Well Name: RAE'S CREEK 25 36 22 FED COM	Well Location: T25S / R36E / SEC 22 / SWSE / 32.1091419 / -103.2501764	County or Parish/State: LEA / NM
Well Number: 095H	Type of Well: OIL WELL	Allottee or Tribe Name:
Lease Number: NMNM136231	Unit or CA Name:	Unit or CA Number:
US Well Number:	Operator: MATADOR PRODUCTION COMPANY

Type of Action: APD Change

Procedure Description: BLM Bond# NMB001079; Surety Bond# RLB0015172 Matador requests to skid over to spud the well using a new surface hole location going FROM 200' FSL & 1710' FEL S22-25S-36E TO 170' FSL & 1710'FEL S22-25S-36E, as reflected in this sundry, due to the incorrect size conductor being set in the original location. As reflected in the attached, the completed lateral and bottom hole location for the well remains the same. We understand the NMOCD will then assign the replacement well under this sundry a new API number, leaving the original location with its same API number. The original well will be named RAES CREEK 25 36 22 FEDERAL COM 095Y (API 30-025-54321). The well we will skid to spud will be named RAES CREEK 25 36 22 FEDERAL COM 095H and will be assigned a new API # from NMOCD. Please see the attached supporting docume

LEASE NAME & WELL NO.: RAE'S CREEK 25 36 22 FED COM 095H

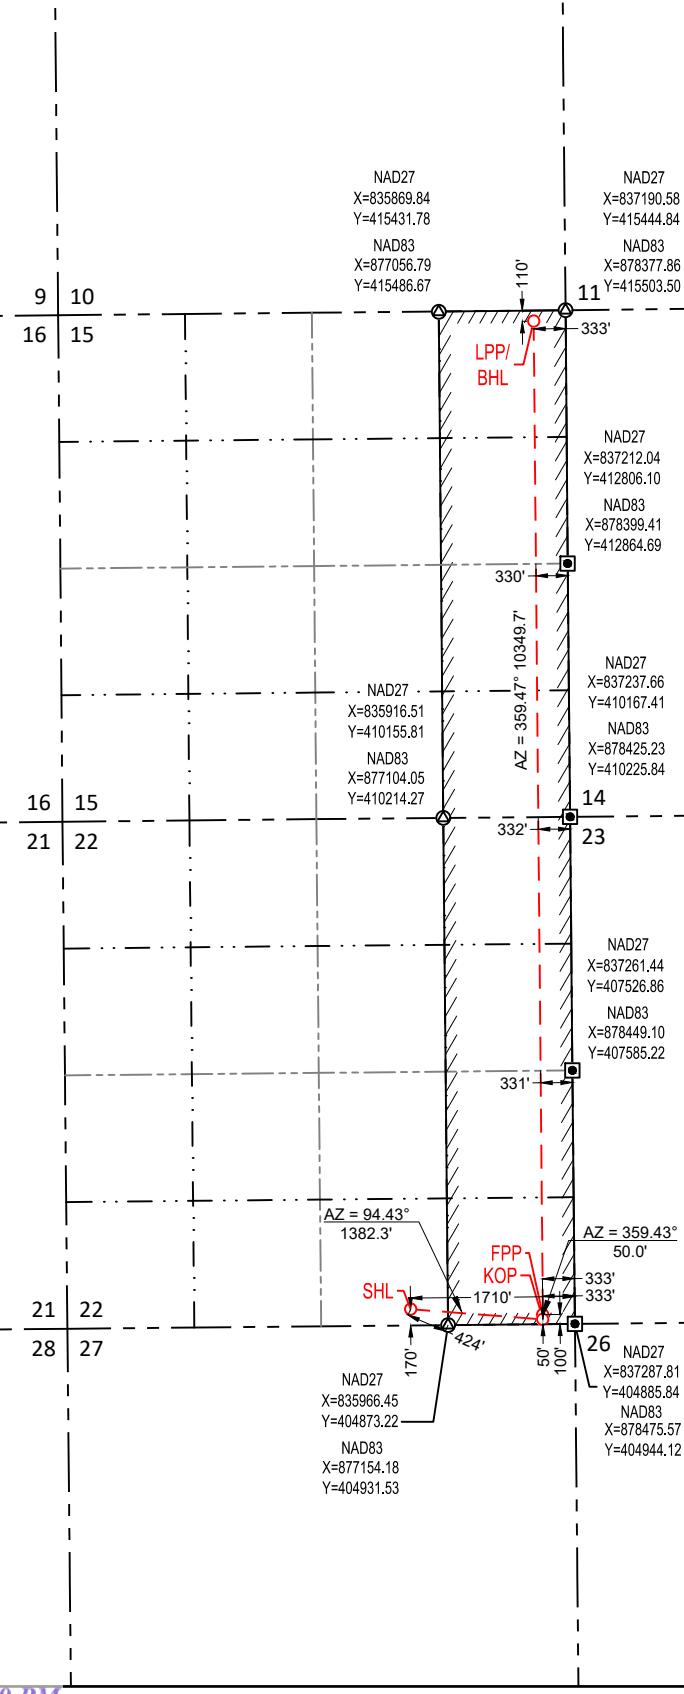
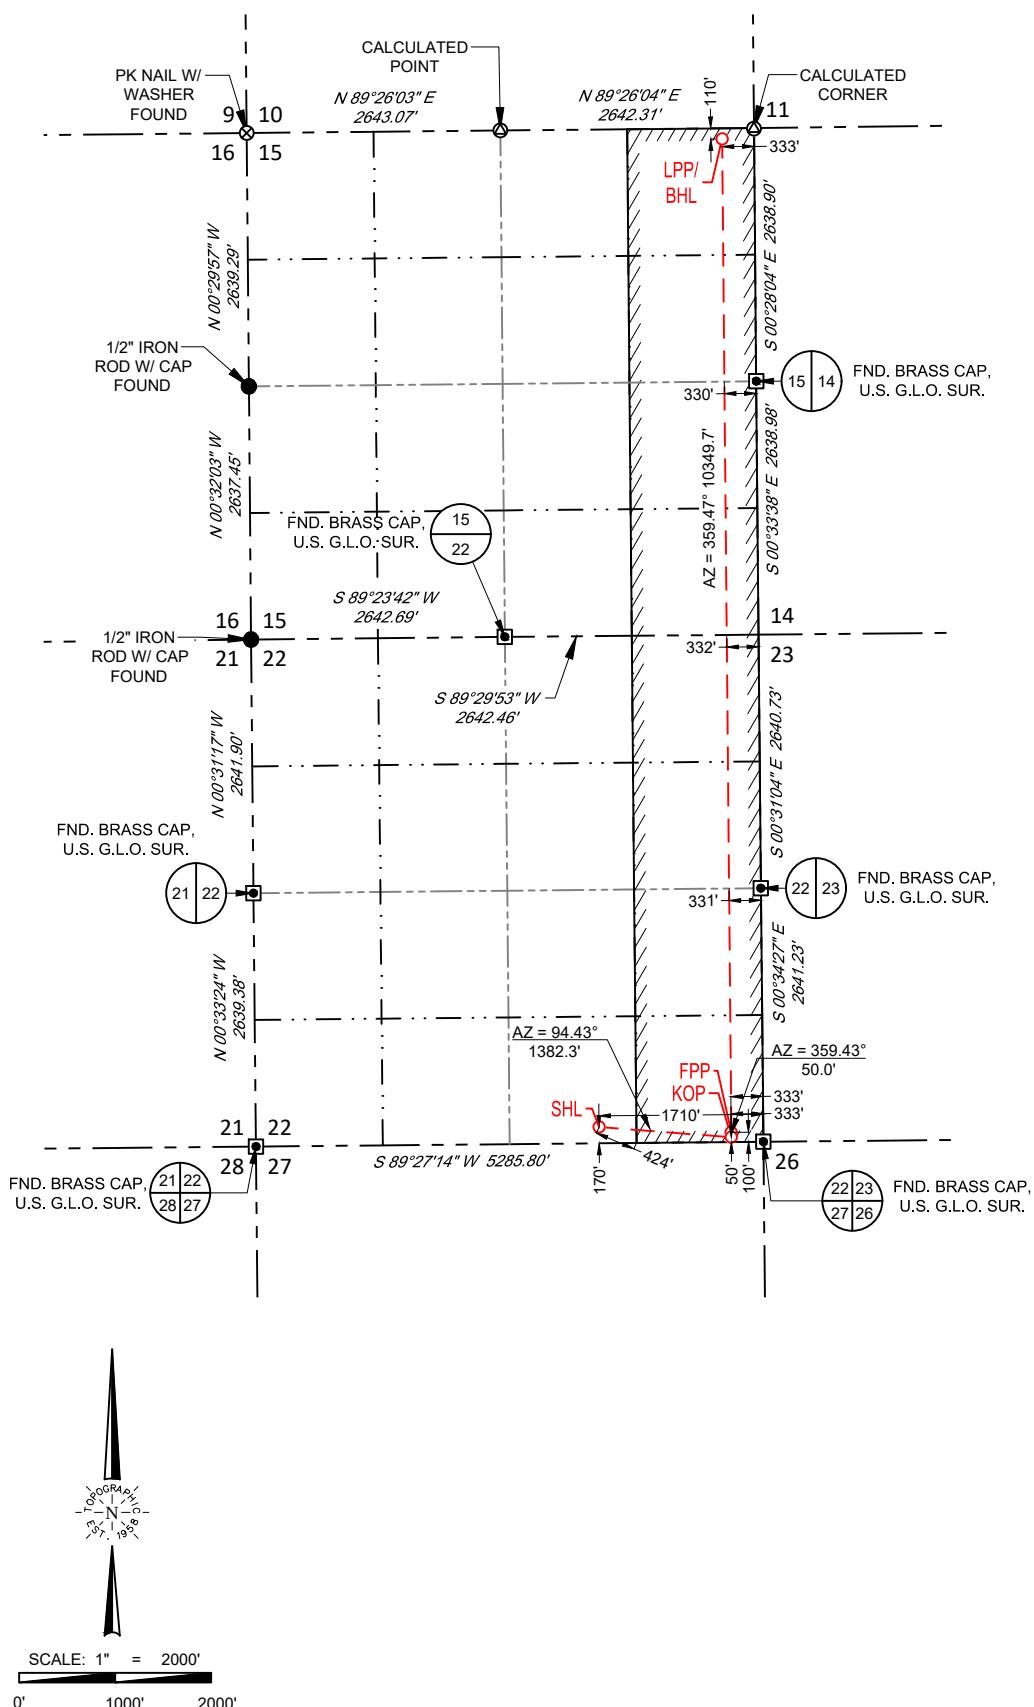
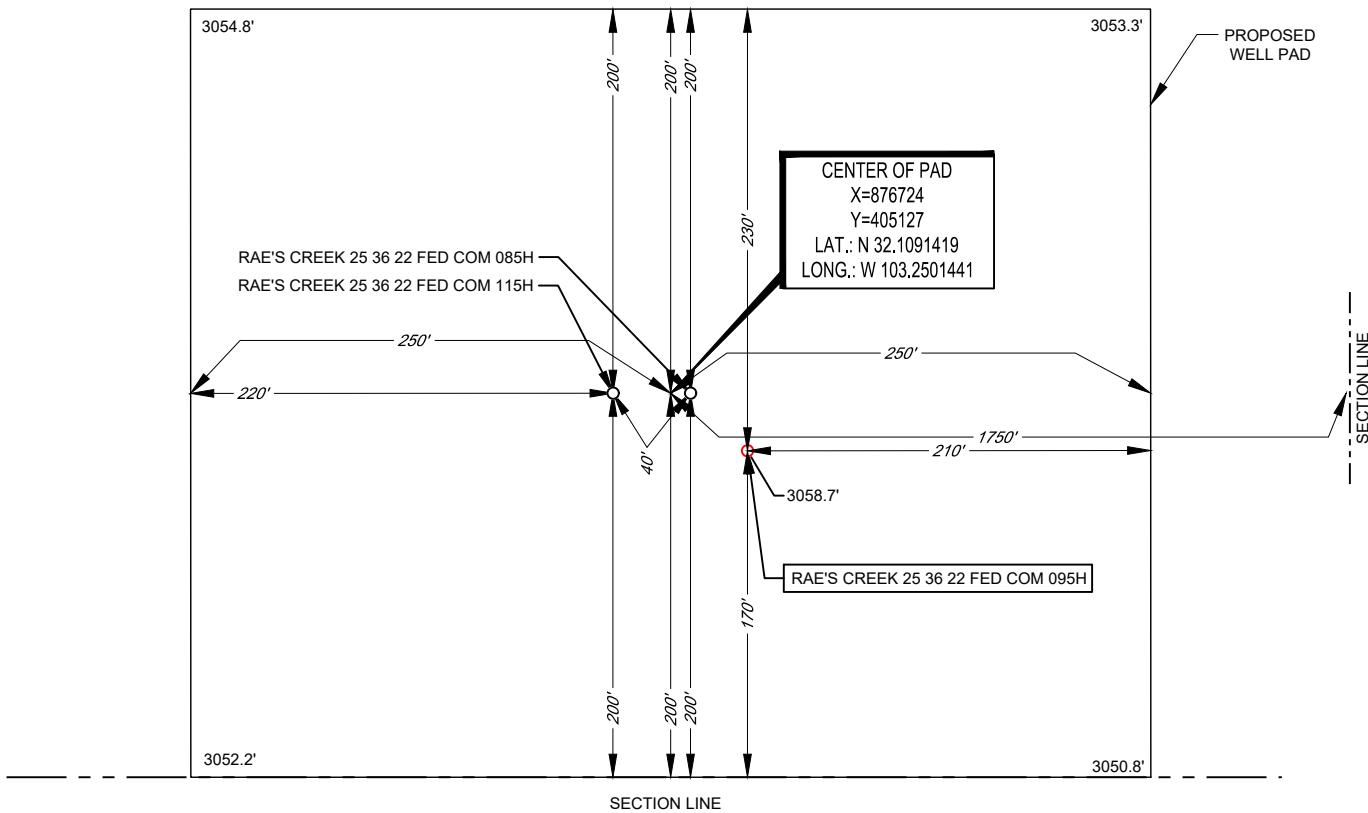
- Matador requests to change the surface hole location from 200' FSL to 170' FSL as per the attached C-102. Directional plans and drilling plan has been updated accordingly.

Raes Creek Fed Com #095H – Plug Back Design

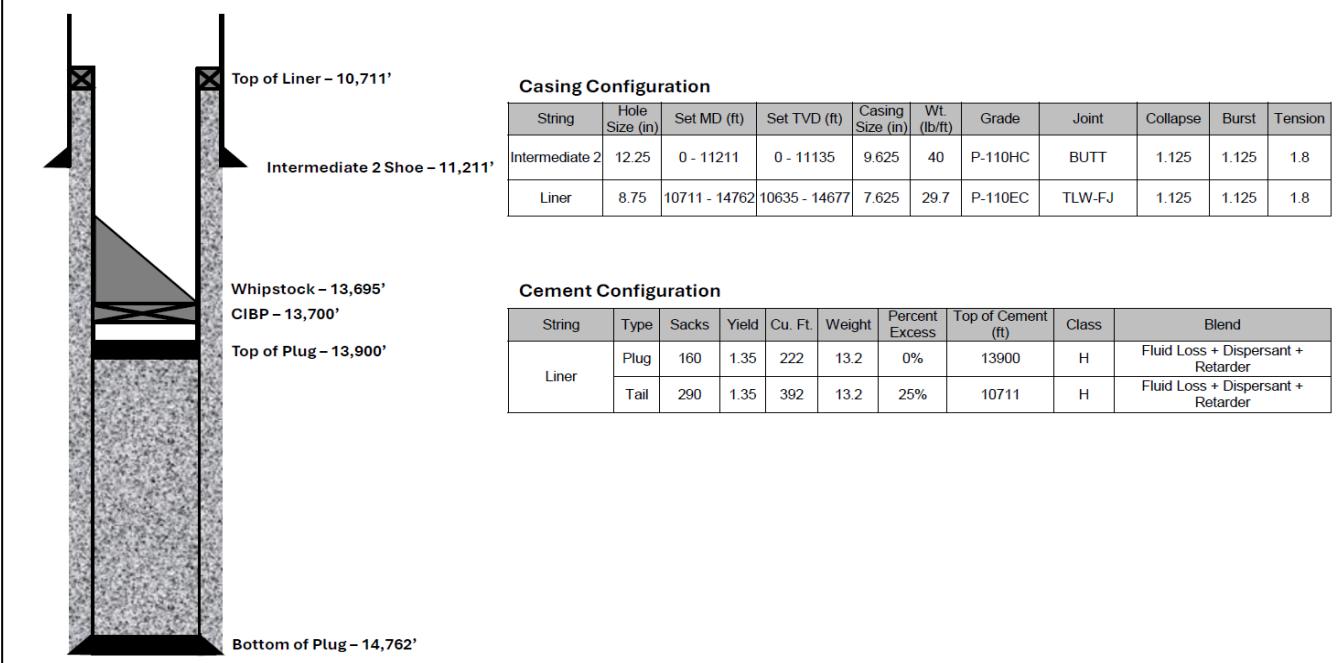
The 8.75" pilot hole will be drilled to ~14,772' MD and then cased and cemented. A cement plug will be put in place inside the liner from ~14,762' to ~13,900', then a cased hole whipstock will be set at ~13,700' MD to mill a window in the casing for the 6.75" production section.

The pilot hole plugging procedure is approved as written, with the modification that more cement will be needed to have the inside plug from 14,762 ft. to 13,900 ft. Please adjust the cement volume accordingly. Note plug tops on subsequent drilling report. The BLM is to be contacted 24 hours prior to the commencement of any plugging operations (575-689-5981 Lea County) and when tagging the plugs.
